1 **B-98 Microwave Site Refurbishing, \$364,000**

Post Construction Inspection Report

**EXISTING 387 ft. (118 m)
GUYED TOWER**

Mary March Hill, NF.

2.1.5 Replacement of the Complete Obstruction Lighting System On The tower - Complete

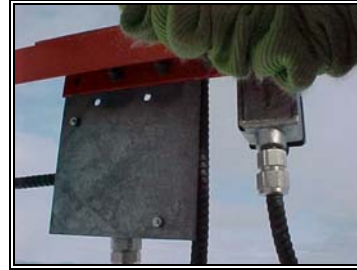
As was inspected in the tower and outside the building, all work appears to be complete and work is of good quality.

All connectors are stainless and receptacles have been installed as per specification.
